SPARC® Enterprise M8000/M9000 Servers Product Notes

For XCP version 1061

FIGURE 1-18 SPARC Enterprise M8000 Server + Power Cabinet Bottom View

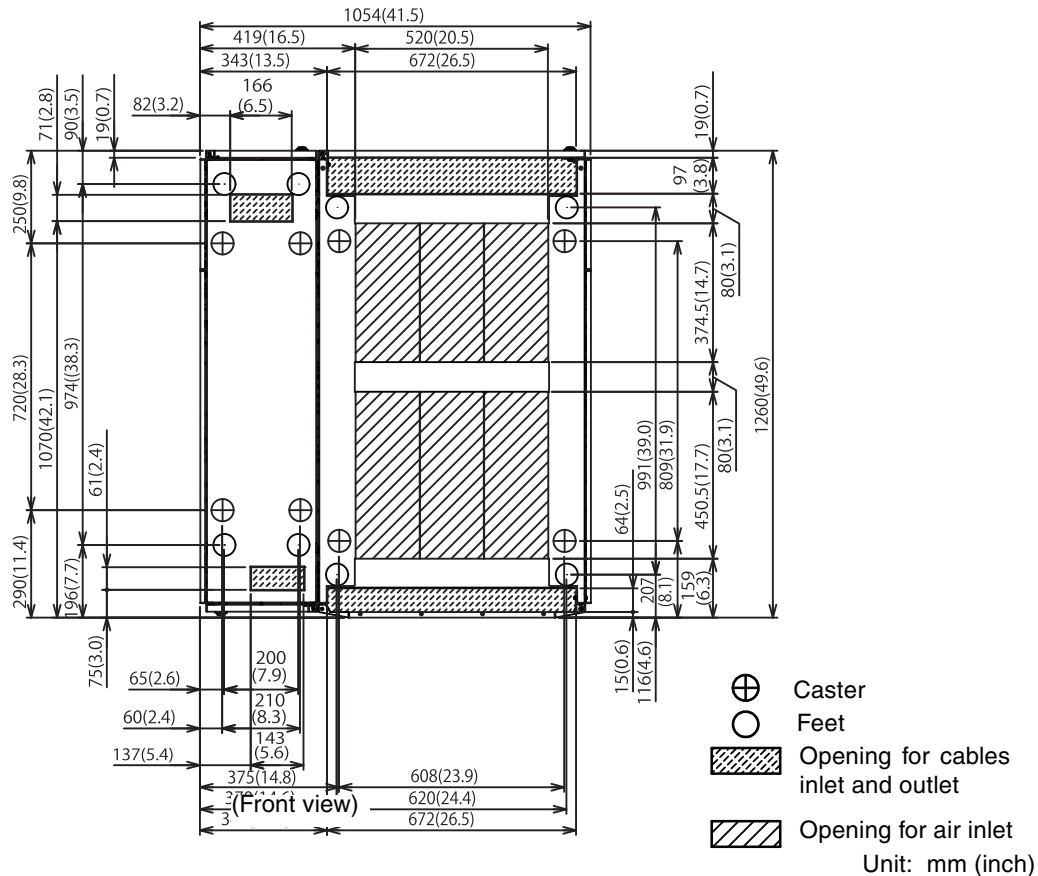
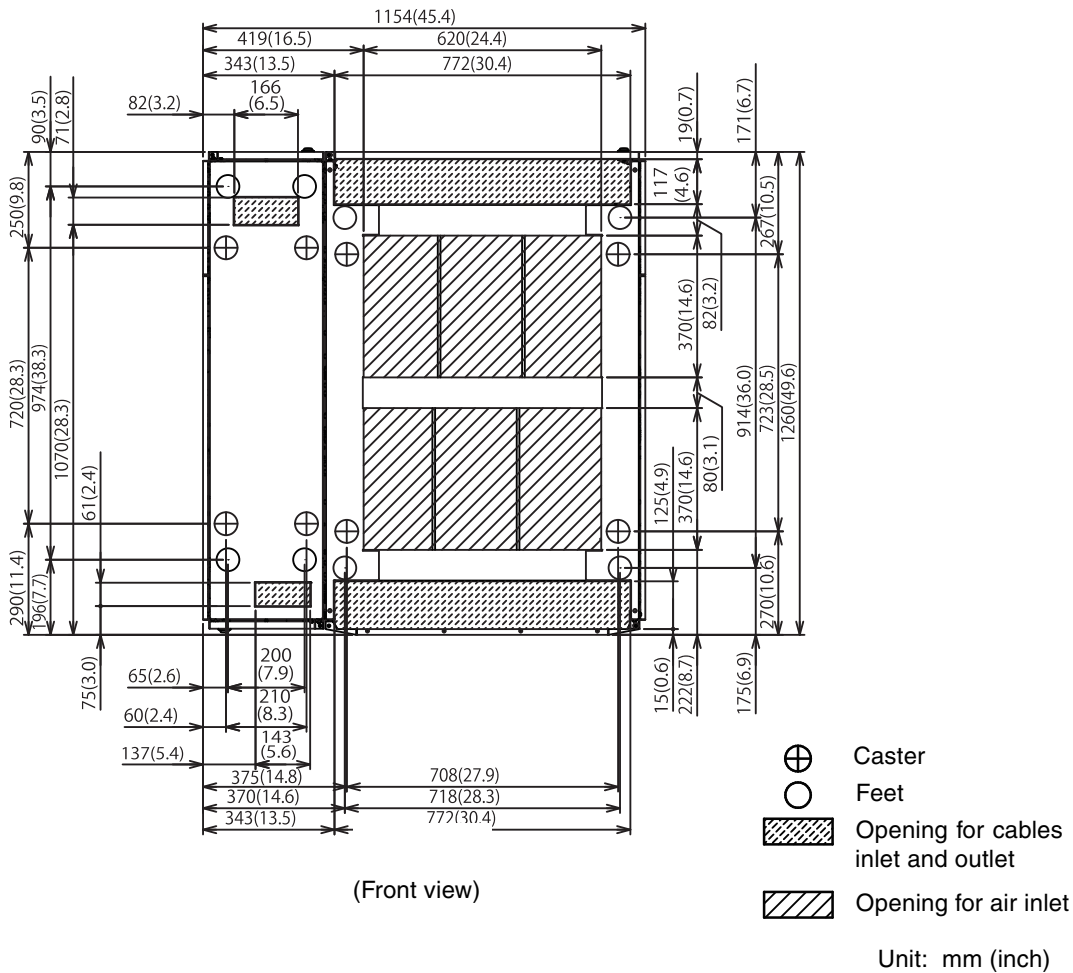
This is to correct the description in Section 1.2.2.2, "Bottom View of the Components", FIGURE 1-18 SPARC Enterprise M8000 Server + Power Cabinet Bottom View and FIGURE 1-20 SPARC Enterprise M9000 Server (Base Cabinet) + Power Cabinet Bottom View. The correct figures are as follows:
